Planning Commission Hearing Date: May 5, 2026
Board of Commissioners Hearing Date: May 28, 2026

STAFF ANALYSIS

CASE NO.:	SLUP-26-1248044	File ID #: 2026-0490
Address:	4733, 4773 & 4775 Memorial Drive, 30032	Commission District: 4 Super District: 6
Parcel ID(s):	18 012 13 033, 18 012 13 015, 18 012 13 001	
Request:	Application of QuikTrip Corporation for a Special Land Use Permit (SLUP) to allow fuel pumps in the Town Center character area in the C-1 (Local Commercial) zoning district.	
Property Owner(s):	QuikTrip Corporation c/o Eric Bikas	
Applicant/Agent:	QuikTrip Corporation c/o Eric Bikas	
Acreage:	5.23 acres	
Existing Land Use:	Town Center	
Surrounding Properties:	North: C-1 (Local Commercial) South: C-1, R-100 (Residential Medium Lot-100) East: C-1, R-100 West: C-1	
Comprehensive Plan:	Consistent Inconsistent X

STAFF RECOMMENDATION: APPROVAL WITH CONDITIONS.

SHEET TITLE:
 SITE PLAN

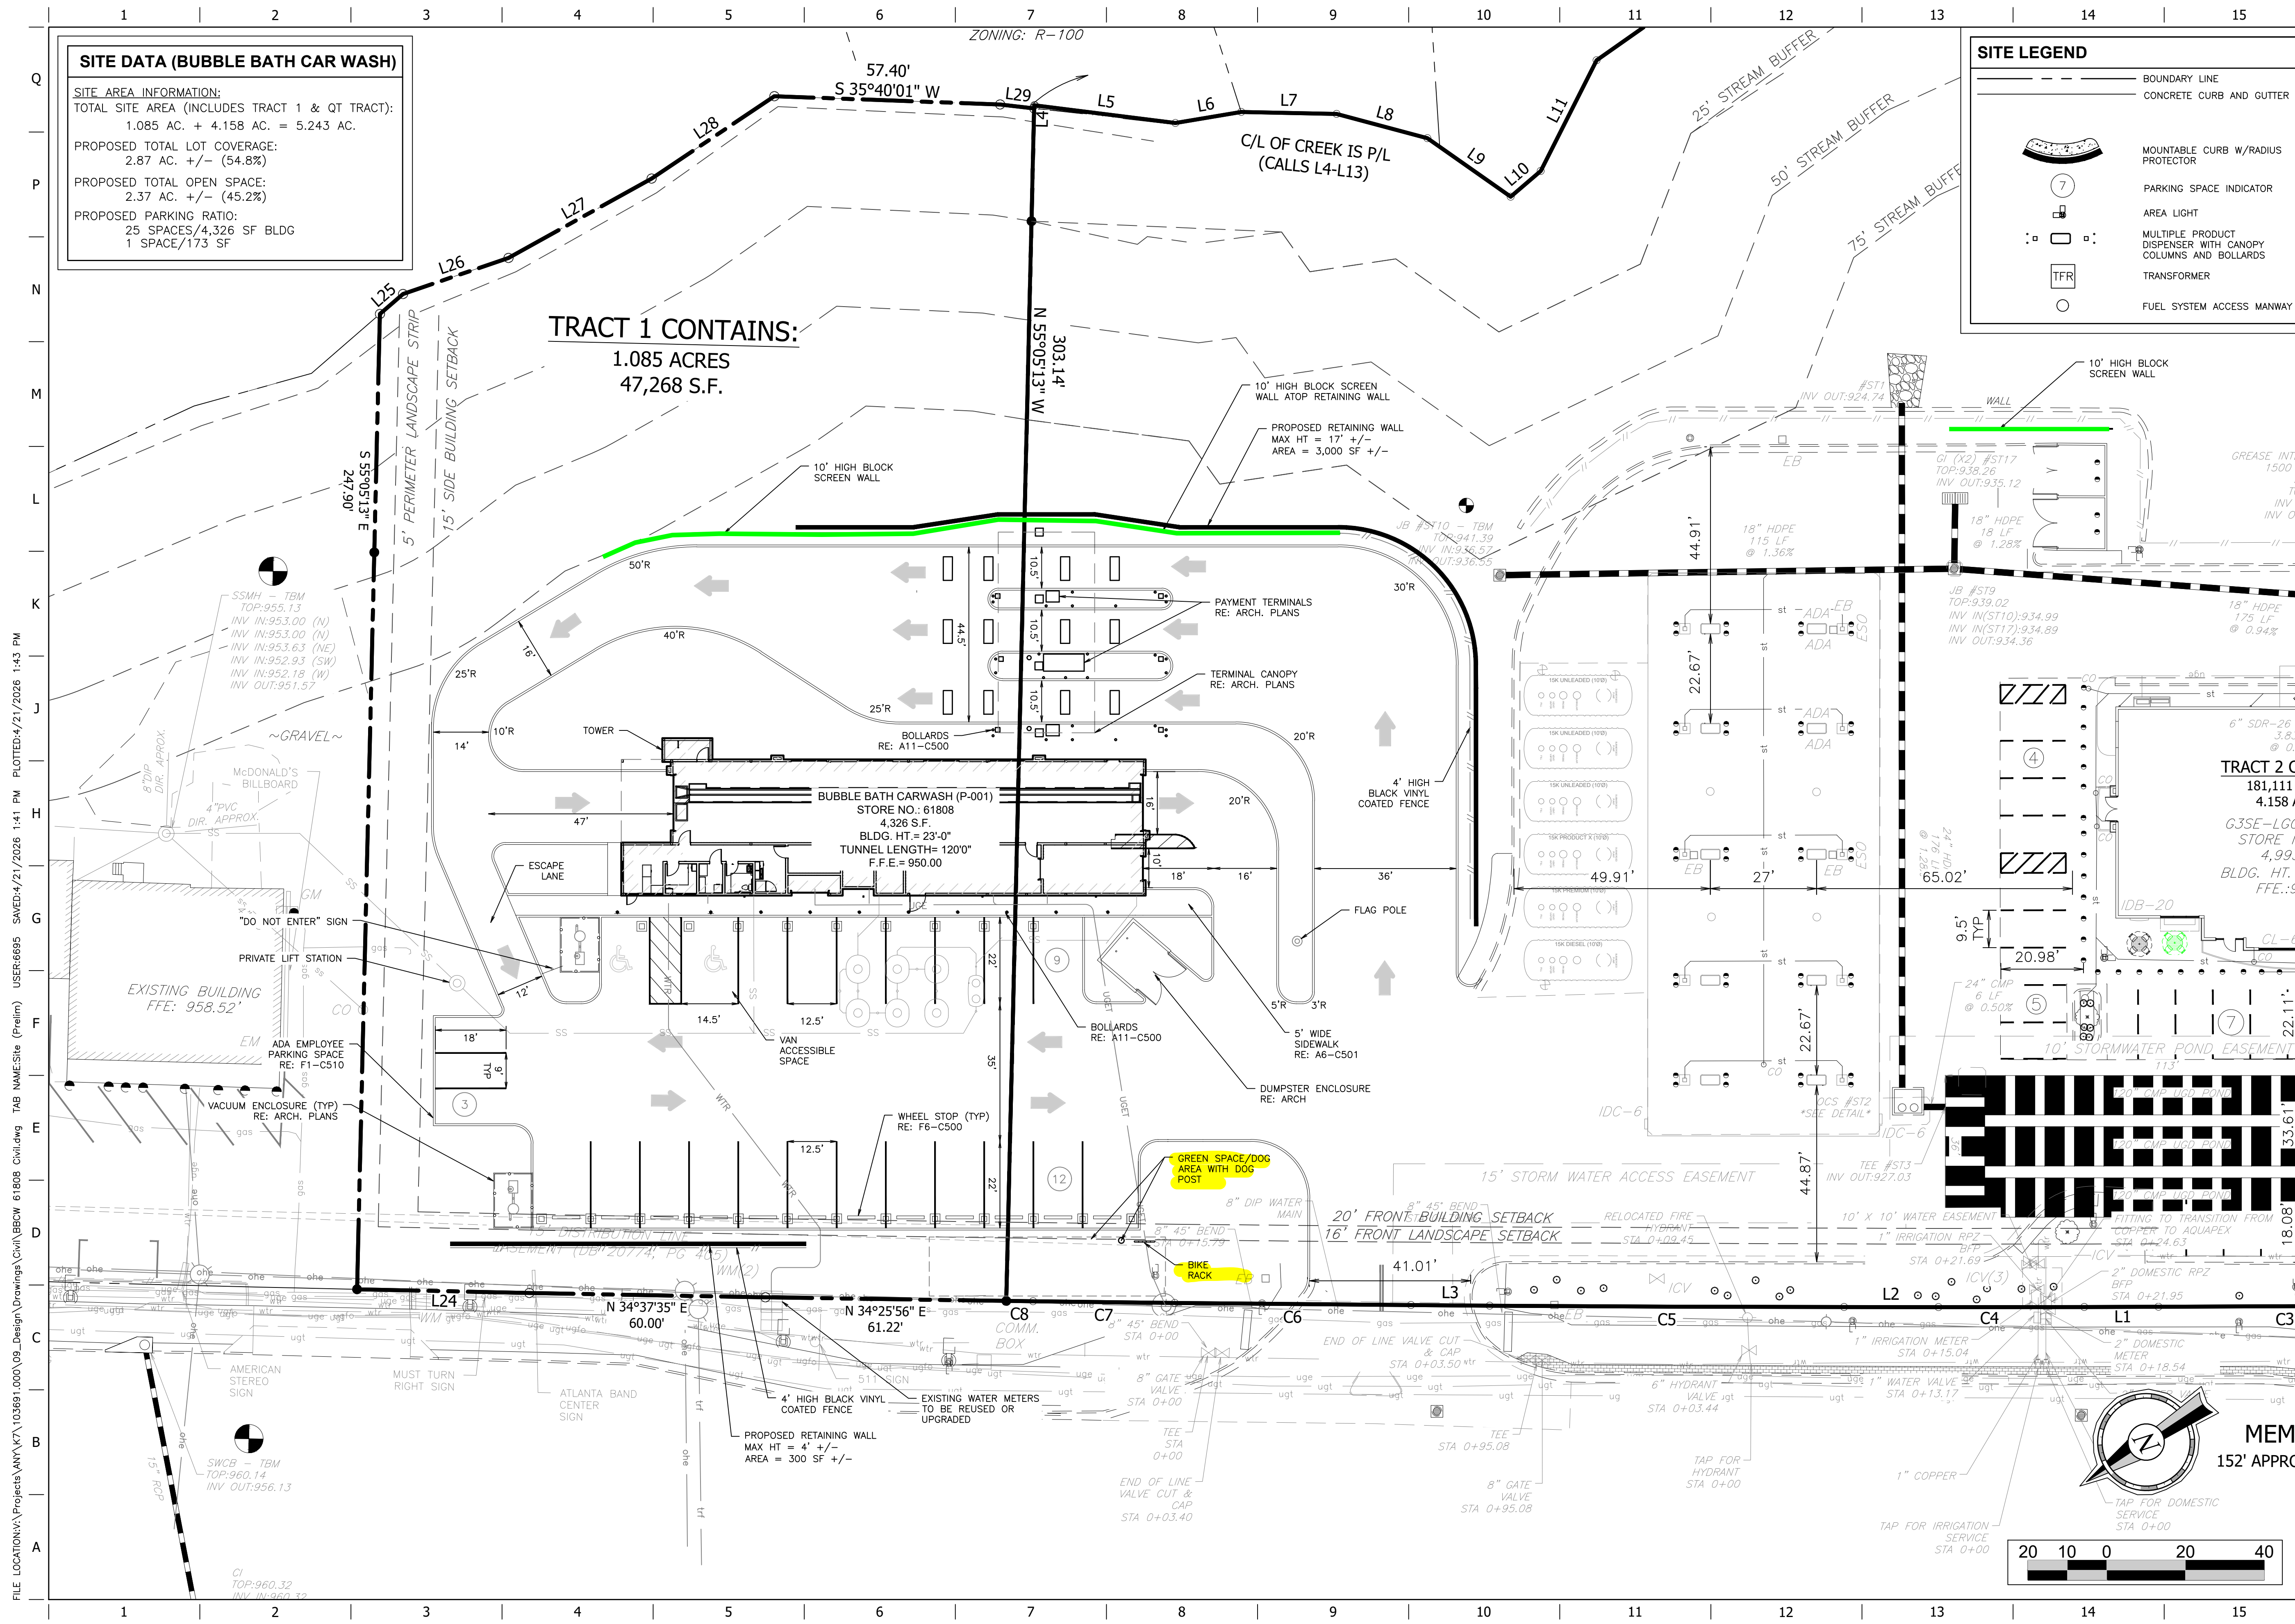
While the proposed car wash is not inherently inconsistent with the existing commercial use, the current site design remains largely auto oriented and does not fully advance these broader planning goals. Accordingly, Staff recommends design enhancements to improve the site’s functionality and visual character, including expanded covered outdoor seating, incorporation of a small green space, and integration of placemaking elements—such as signage or public art—that reflect the identity of the Memorial Drive Corridor.

Full stormwater system is needed with extra measure because this will be consider a hotspot

There is a creek that flows in the back of the property

Operation of fuel pumps or related activities automatically qualify this site as a "stormwater hotspot". Therefore, approved best management practices (BMPs): structural and non-structural are required to ensure compliance with the County's MS4 program and the NPDES permit requirements. A detention facility is required per Sec. 14-40(b)(4) of the code of Ordinance.

Comments: Applicant to show how proposed major mod to allow a car wash is consistent with the Town Center Character Area to encourage pedestrian uses as well as Memorial Drive Corridor Small Area Plan (SAP). Applicant to show compliance with C-1 zoning requirements and car wash supplemental regulations of Section 4.2.13. This is only a preliminary review. A final review will be done upon official submittal of a major mod application

1. Allow an alcohol outlet (beer & wine sales) in conjunction with a convenience store as depicted.
2. Outside vending machines are prohibited. This prohibition shall not restrict outside equipment used for the storage and sale of ice or for Amazon lockers.
3. No car washing allowed on site.
4. Project signage with digital scrolling signage or with changing pictures shall be strictly prohibited.
5. The approval of this SLUP application by the Board of Commissioners has no bearing on the requirements for other regulatory approvals under the authority of the Zoning Board of Appeals, or other entity whose decision should be based on the merits of the application under review by such entity.
6. This SLUP is being issued to QuikTrip Corporation and shall be non-transferable except to an affiliated entity of QuikTrip Corporation
7. If QuikTrip vacates the site, all fuel pumps must be removed.
